RFQ CCC-039 Instructional Building #1 - ADDENDUM 1

(FOR PRE-BID USE ONLY)
PRE-BID REQUEST FOR INFORMATION
COMPTON COMMUNITY COLLEGE DISTRICT
Send to ckober@pcm3.com ONLY!

Date of Pre-Bid RFI: <u>09/20/2018</u> Project Name: Instructional Building 1 Project No: CCC-039 Bid Package No.: N/A Bid Package Description: N/A	Bidder Name: GB Construction, Inc. _____ _____
---	--

1 FIRE DEPARTMENT ACCESS PLAN
 CP0.00 SCALE: 1" = 40'

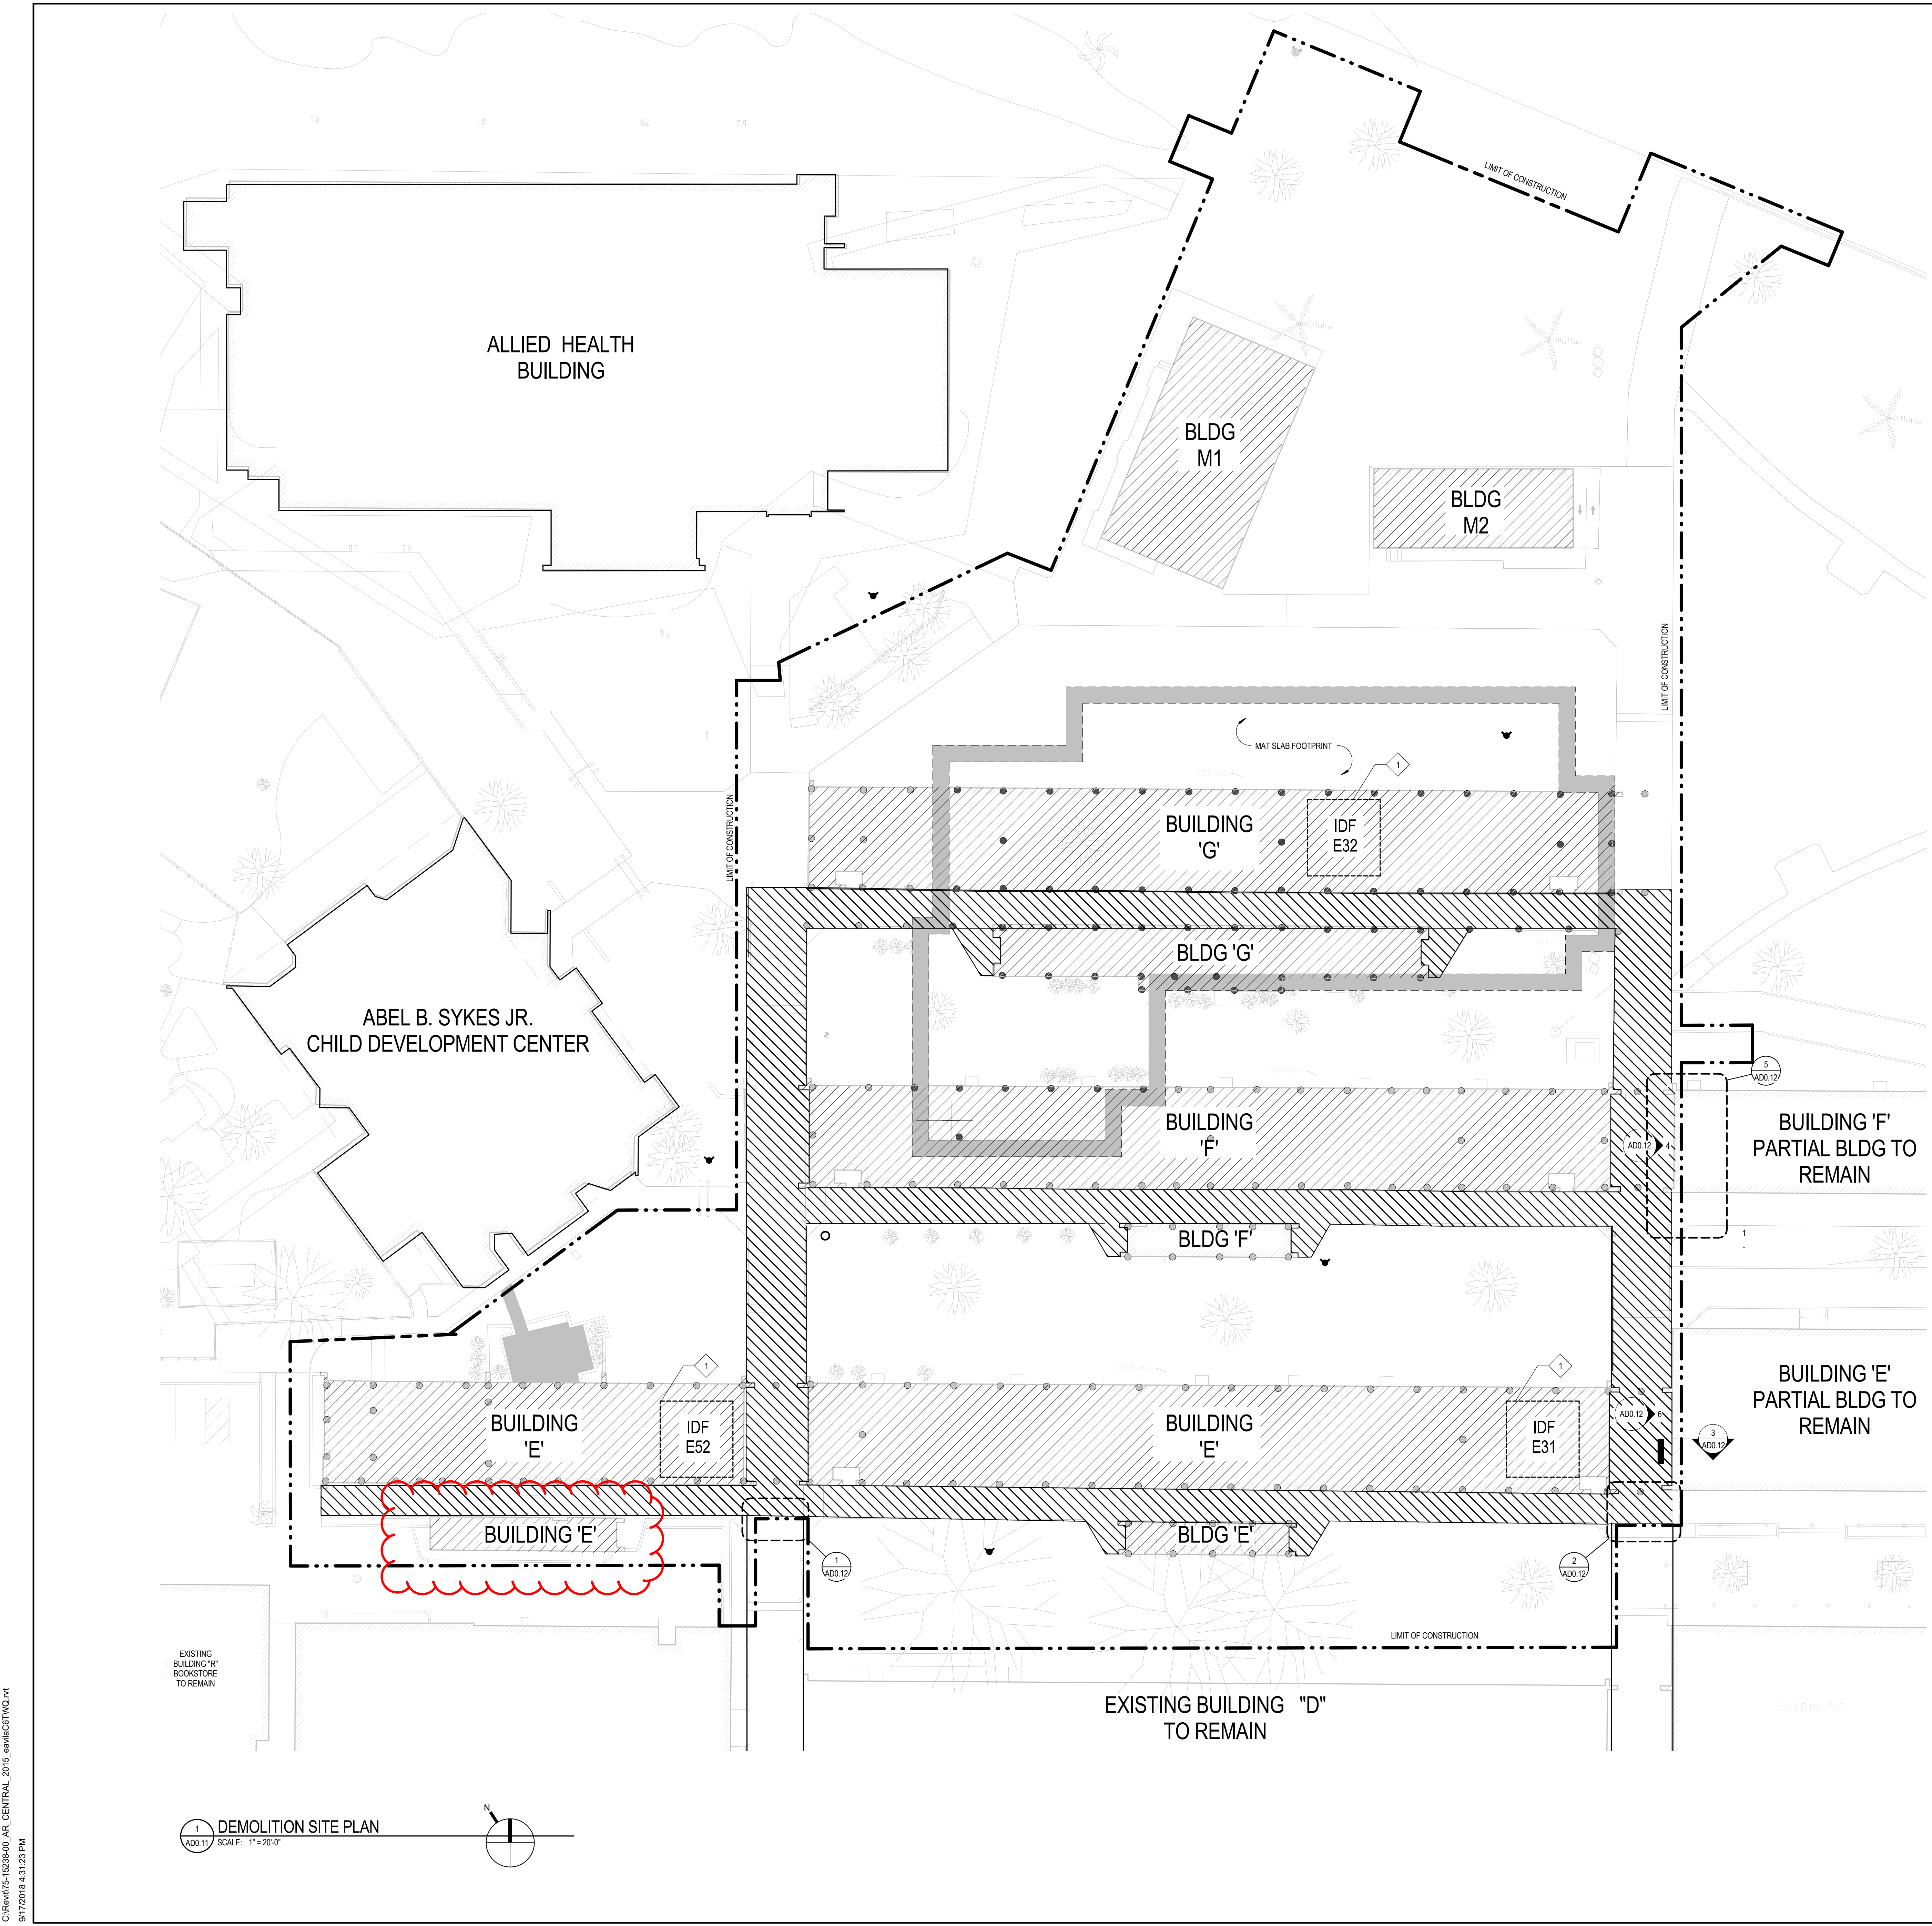
This RFI pertains to Fire Department Access Plan (CP0.00) and Demolition Site Plan (AD0.11).

Item 1. The comment under the description of Local Fire Authority Review says that "Permit Required for Installation". Please advise and clarify.

1. CP0.00: A permit from the local Fire Authority will be required to install the new fire hydrant and FDC (Item 3 and Item 11 on C5.01) located just east of the new building.
2. See attached plan of Building E for location of below grade pylons.

2 STR-01 SOLID SURFACE @ PLATFORM OVERHANG
SCALE: 3" = 1'-0"

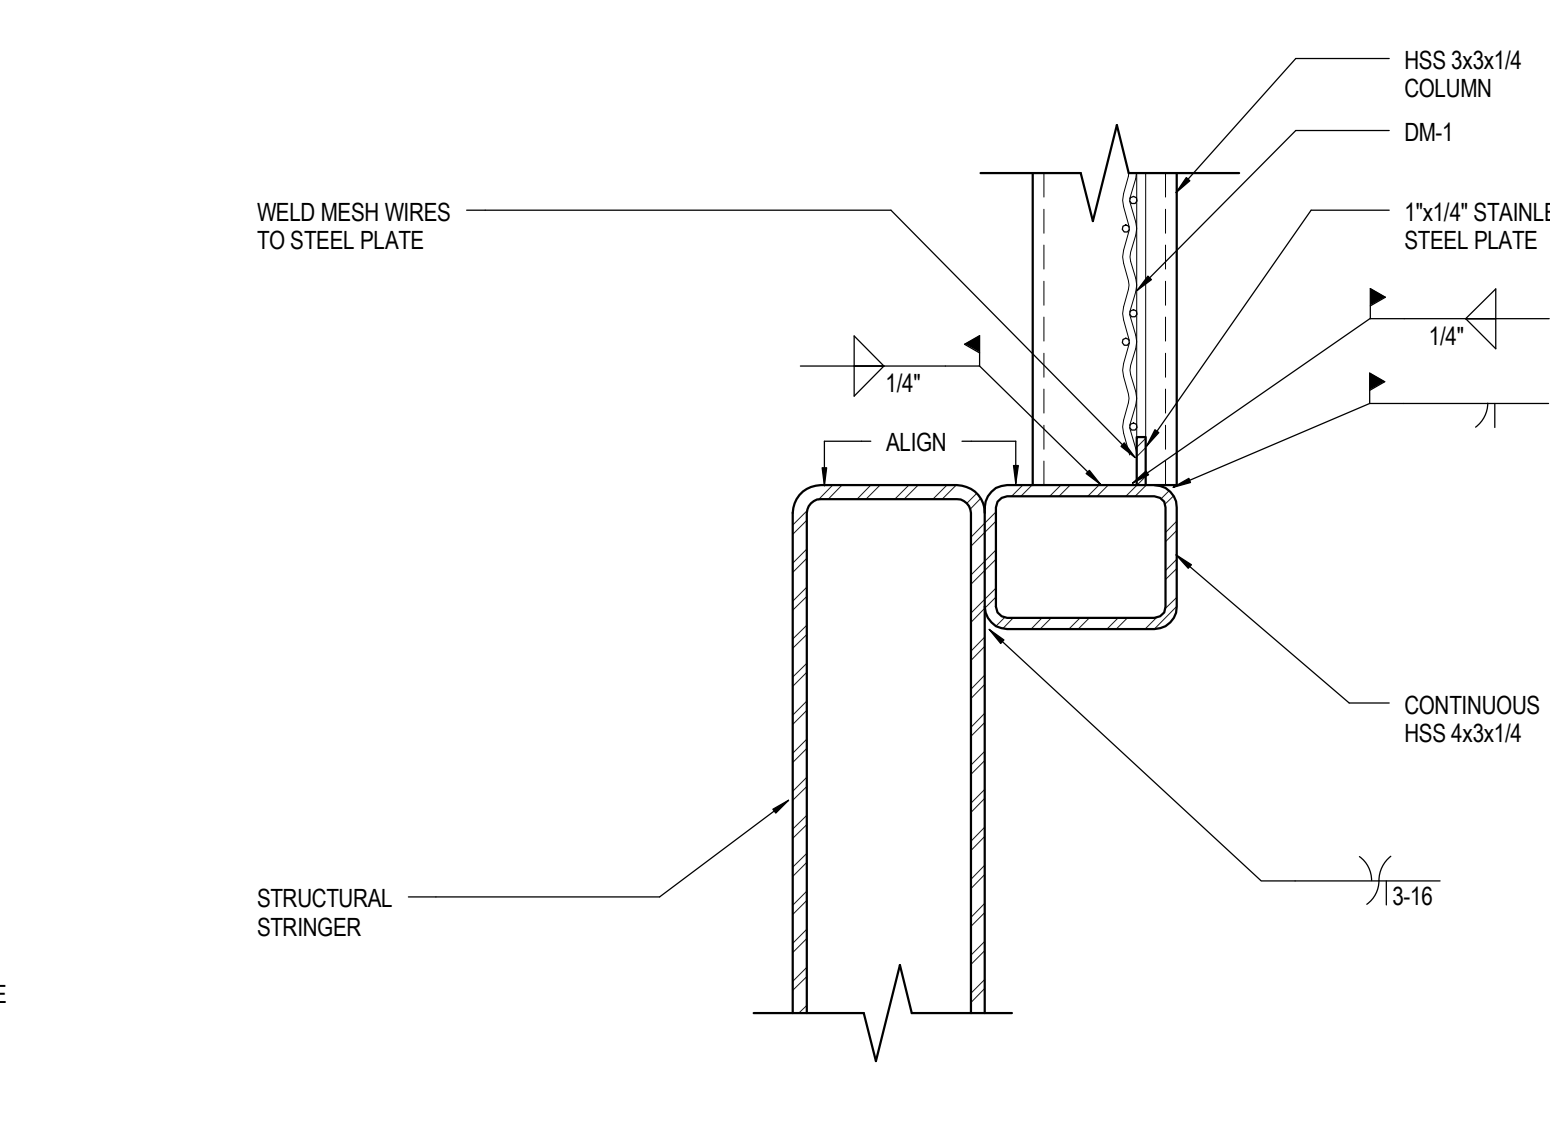
This RFI pertains to Stair Details (A8.07). The exact location of detail #2 STR-01 Solid Surface @ Platform Overhang is not clear. Please advise.

- The referenced item is the platform beneath Stair #1. The path to this detail is as follows:
1/A1.01 > 1/A8.01 > A8.01 elevation 12 > 19/A8.07 > 2/A8.07

EXTERIOR WALL TYPES

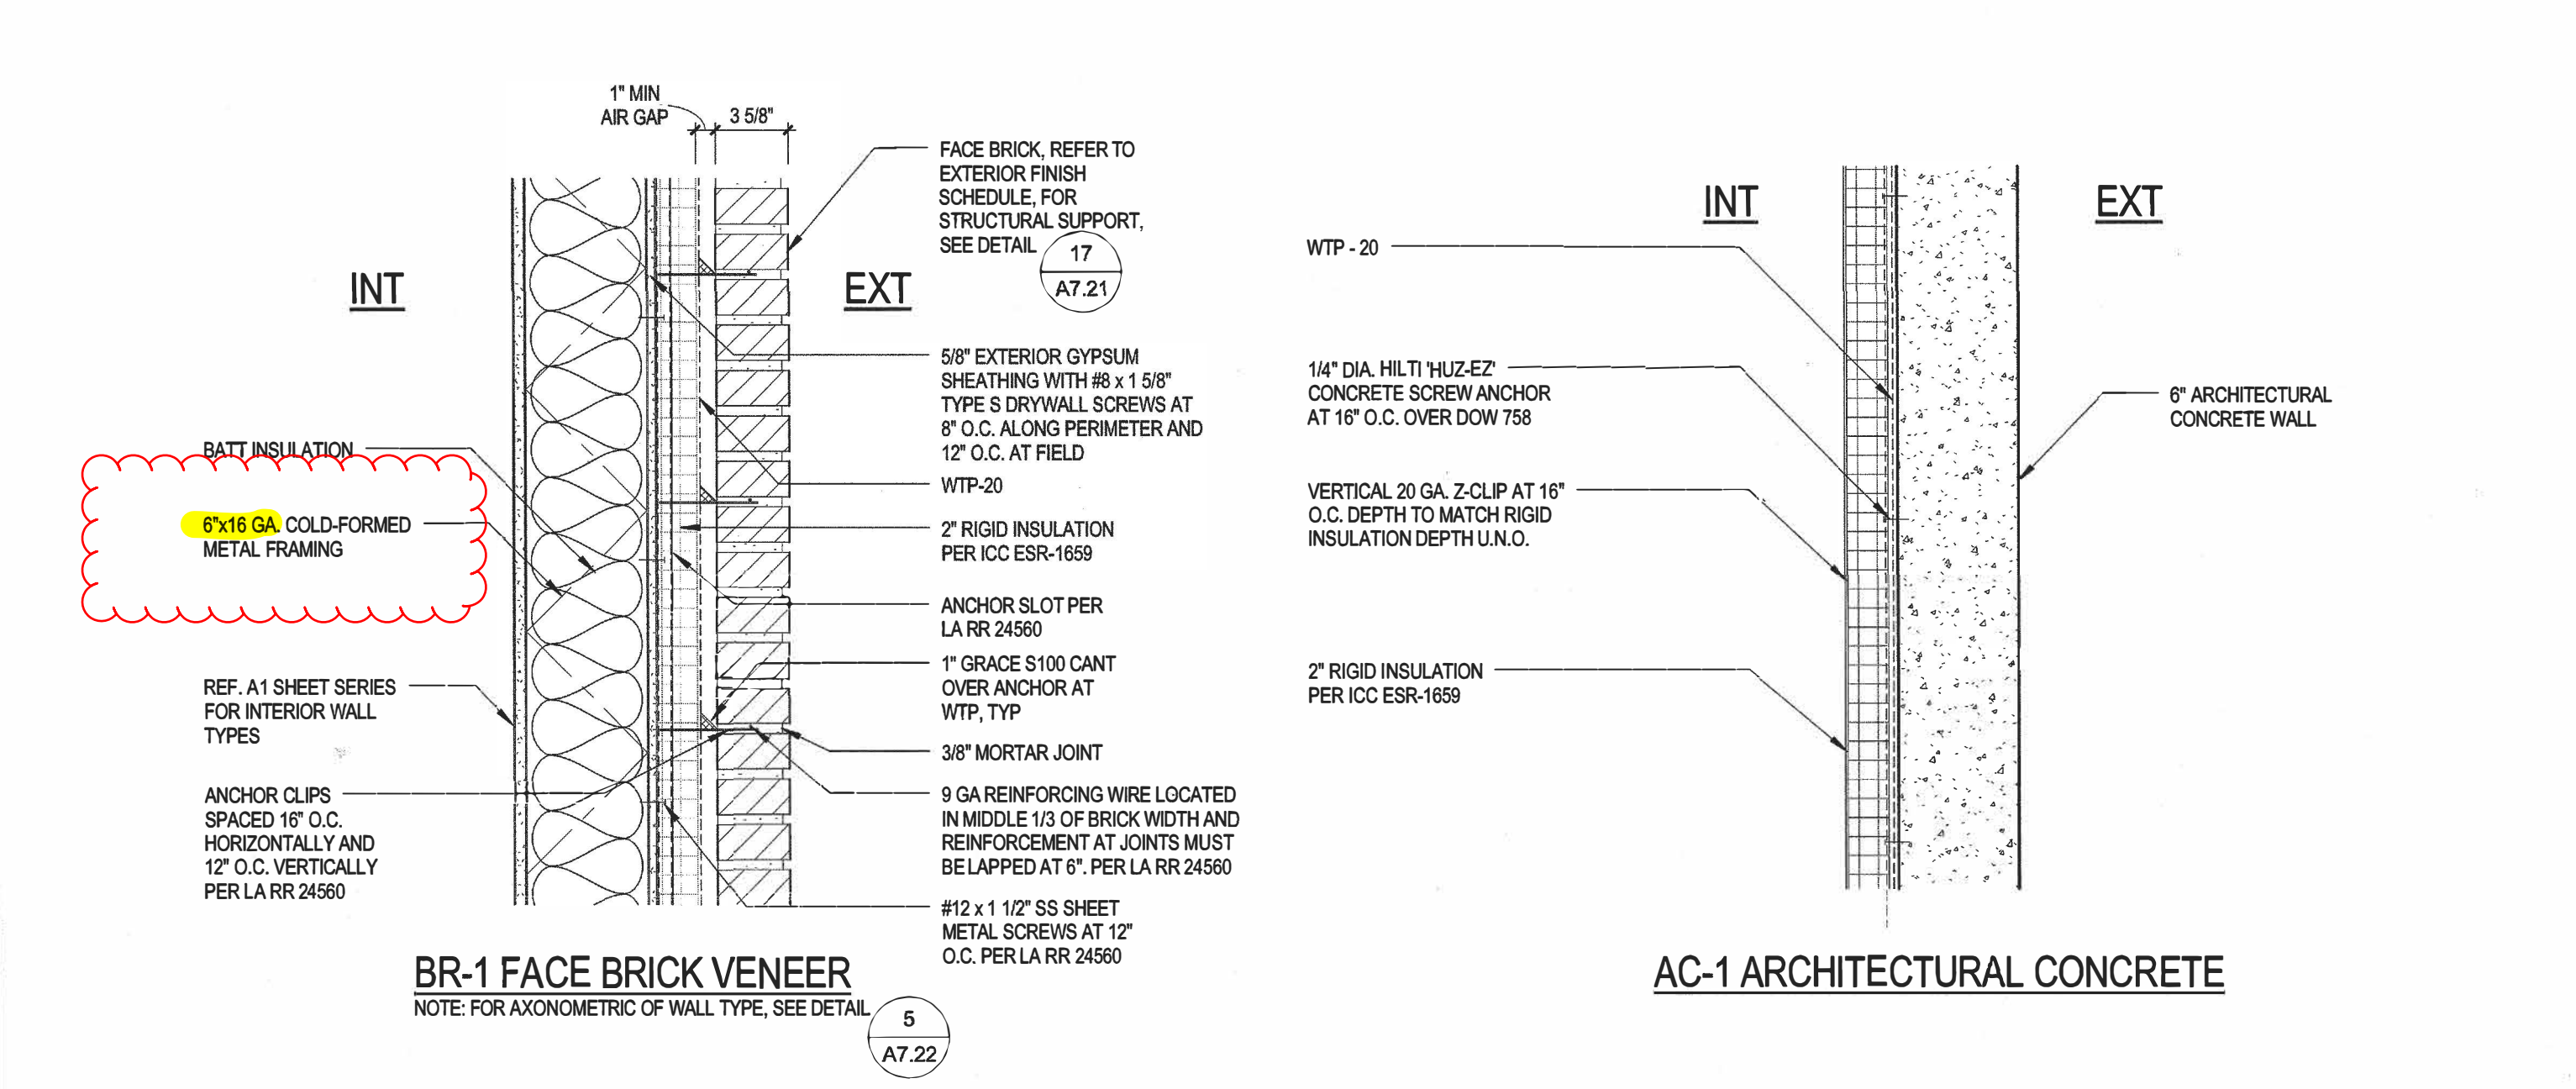
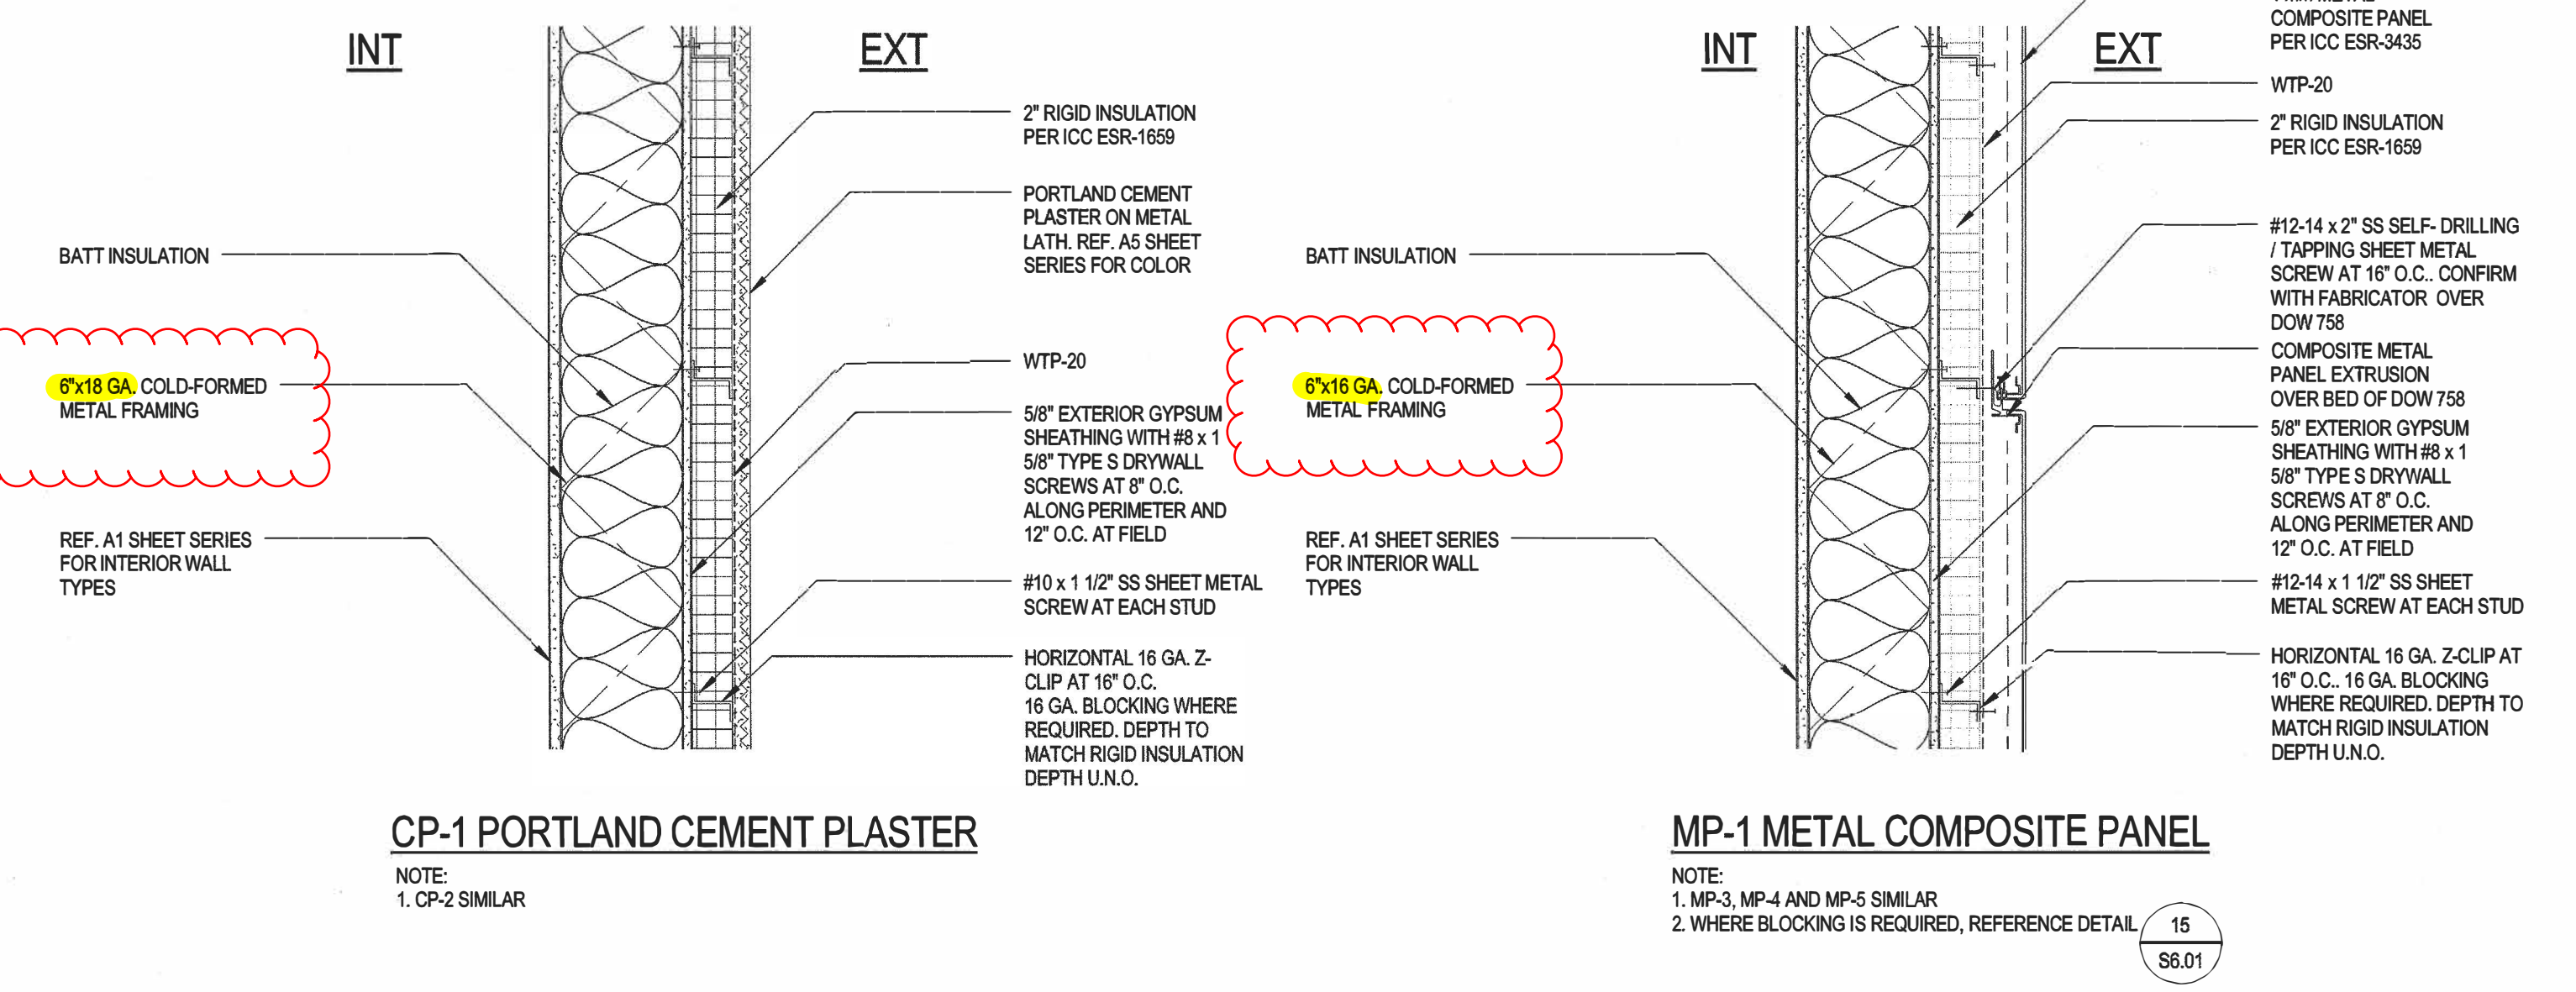
This RFI pertains to Wall Types plan(A9.01). The cold-formed metal framing of exterior walls are not clear (CP-1: 6"x18 GA / MP-1 & BR-1: 6"x16 GA). Please advise.
